ADDENDUM #1

Reference: Control Room Upgrade
Northern Utah Community Correctional Center
Division of Adult Probation & Parole – Ogden, Utah
DFCM Project No.06178120

addendum | N.U.C.C. CONTROL ROOM REMODEL

Architectural
Addendum

SHEET NAME:
SUPPLEMENTAL WINDOW DETAIL

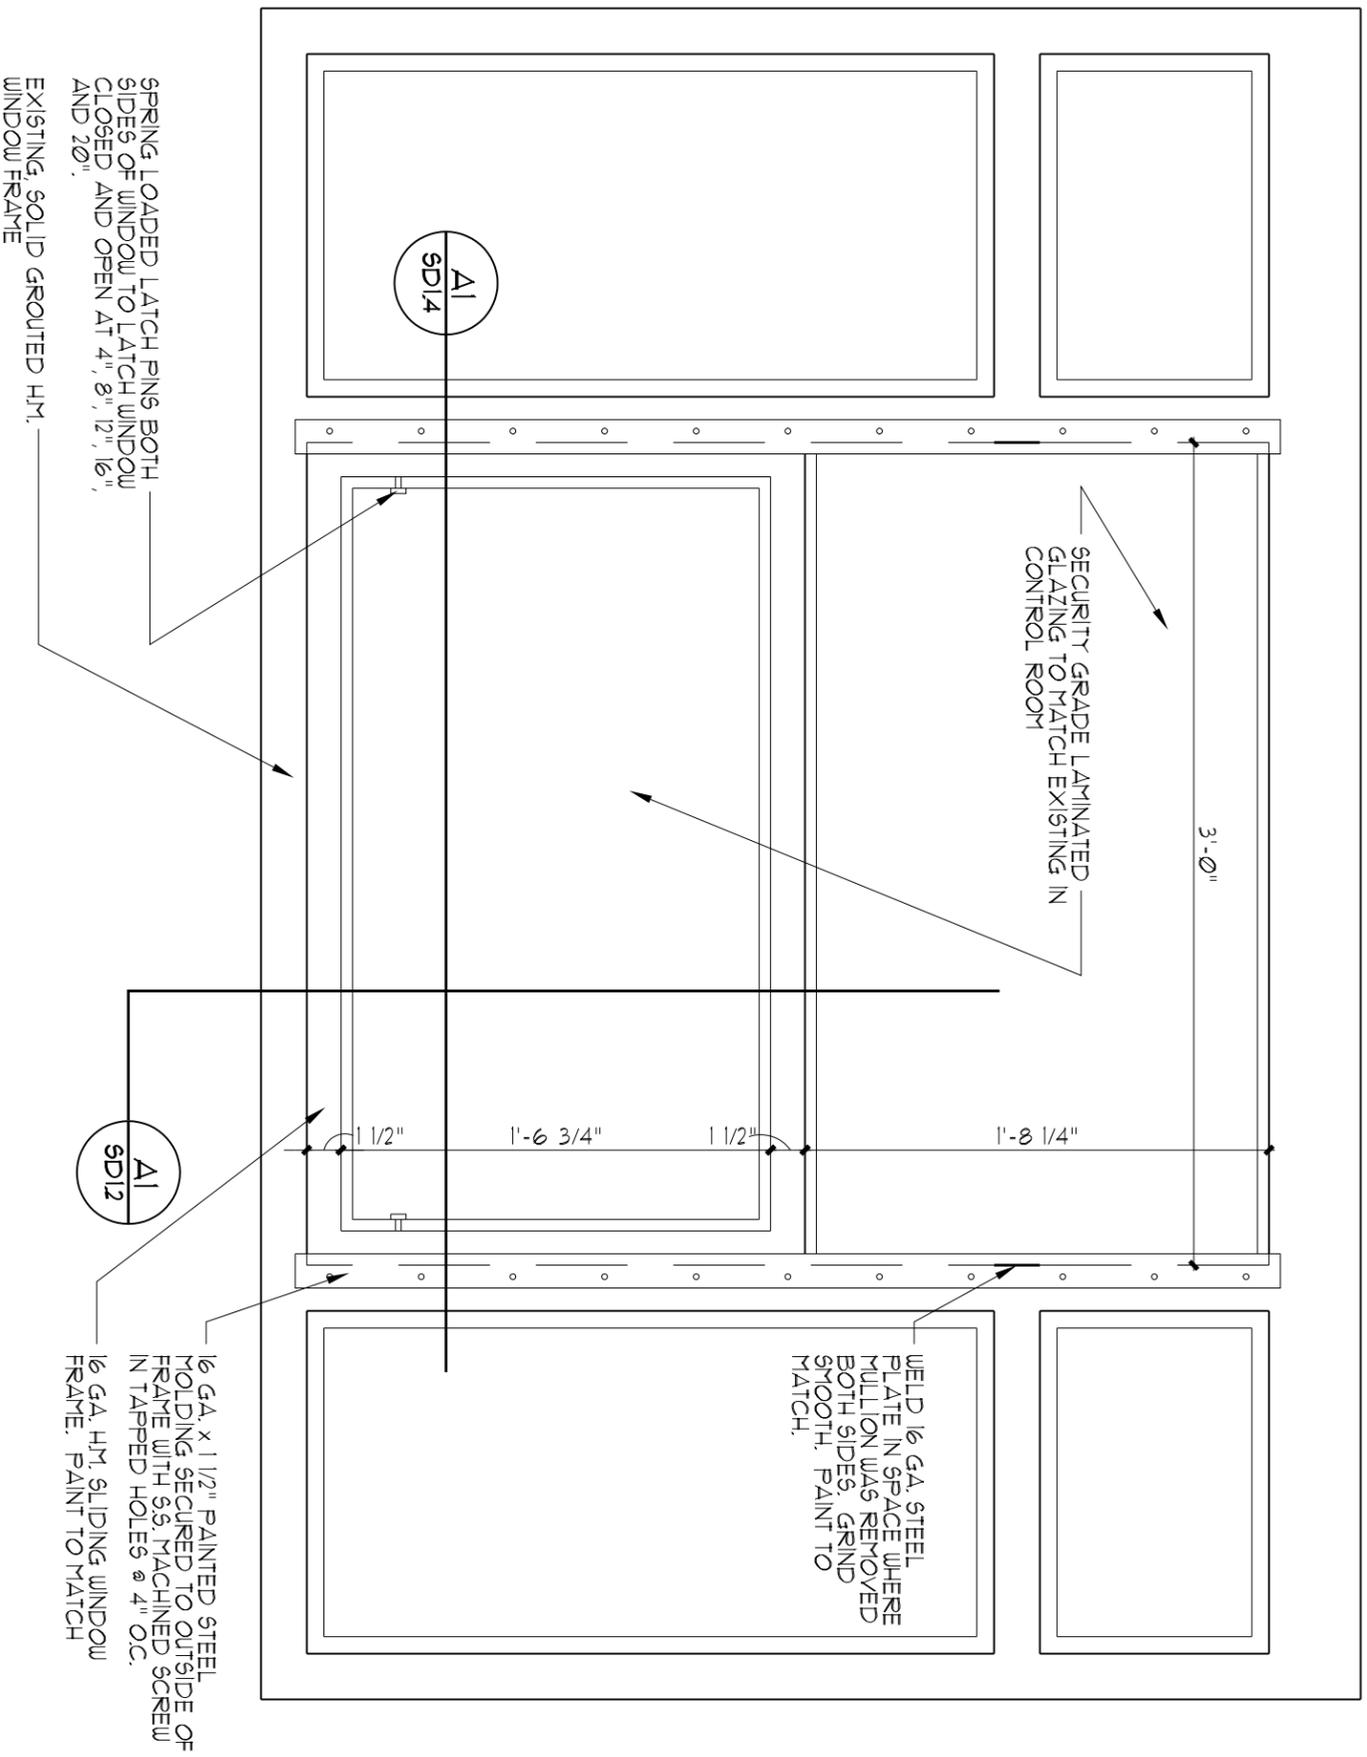
Drawings. Details C2/AE501, C3/AE501, C4/AE501 and D5/AE501 have been revised and re-issued as Supplemental Drawings SD 1.1, SD 1.2, SD 1.3 and SD 1.4.

SPRING LOADED LATCH PINS BOTH SIDES OF WINDOW TO LATCH WINDOW CLOSED AND OPEN AT 4", 8", 12", 16", AND 20".

EXISTING, SOLID GROUTED HM WINDOW FRAME

1/2" GA. x 1 1/2" PAINTED STEEL HOLDING SECURED TO OUTSIDE OF FRAME WITH 5/8" MACHINED SCREW IN TAPPED HOLES @ 4" O.C.

1/2" GA. HM, SLIDING WINDOW FRAME. PAINT TO MATCH

WELD 1/2" GA. STEEL PLATE IN SPACE WHERE MILLION WAS REMOVED BOTH SIDES. GRIND SMOOTH. PAINT TO MATCH.

SUPPLEMENTAL DOOR JAMB DETAIL

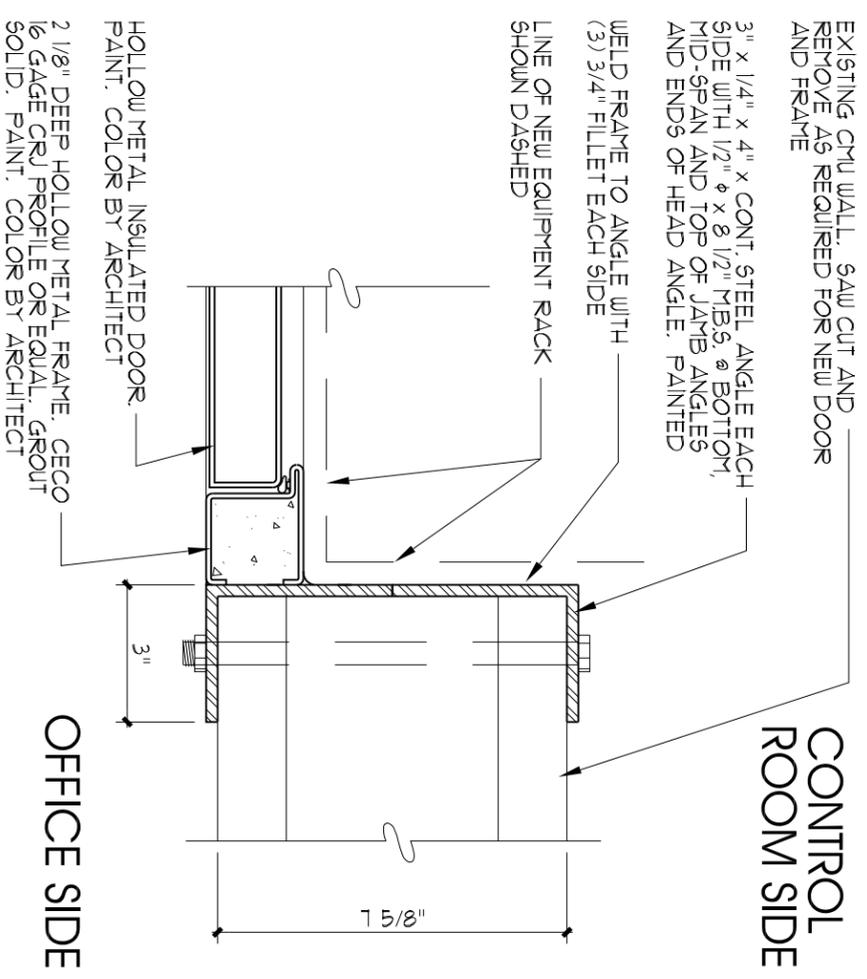
Drawings. Sheet AE101, Construction Floor Plan. Clarification: The new equipment rack is to be installed within the masonry opening for the new hollow metal door and frame. Door #01, to provide clearance for the existing electrical panel. Refer to revised Detail C4/AE501 Supplemental Drawing SD 1.3.
